**RESPONSE LETTER**

KPRG Project No. 13905

Re: Site Investigation Review Letter  
S74 W16834 Janesville Road, Muskego, WI 53150  
FID# 268077480, BRRTS# 02-68-543070

JILL'S DRY CLEANERS  
MUSKEGO, WISCONSIN

FIGURE 1

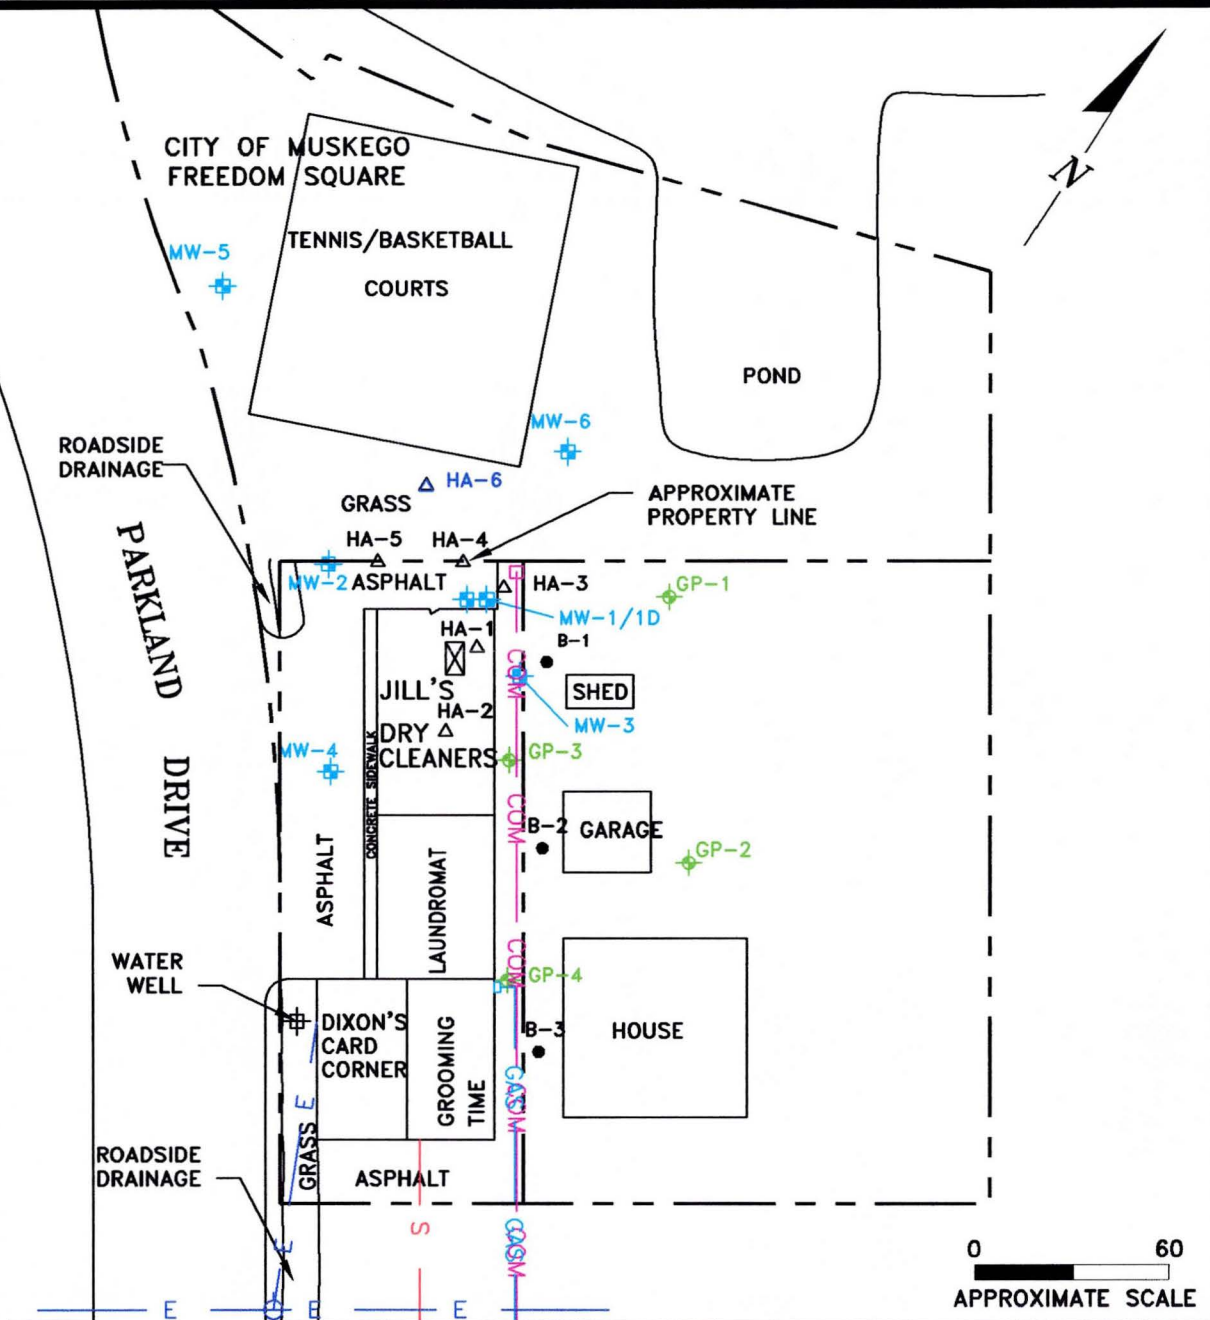
WDNR Item 1: Additional soil samples north of the source area will need to be collected in order to determine the degree and extent of soil contamination in both the lateral and vertical directions. Specifically samples should be collected north of samples HA-4 and HA-5 and beneath samples HA-1, HA-2 and HA-3. Samples should be analyzed for the chlorinated compounds previously detected.

Response: Based on a review of the soil data from sample locations HA-4 and HA-5 along the north property boundary of the Jill's facility, it is understood why the WDNR is requesting some additional soil sampling to the north of these locations. At this time one additional soil sample would be proposed to the north, half-way between the two noted locations. It is identified as proposed location HA-6 on Figure 1 in Attachment A.
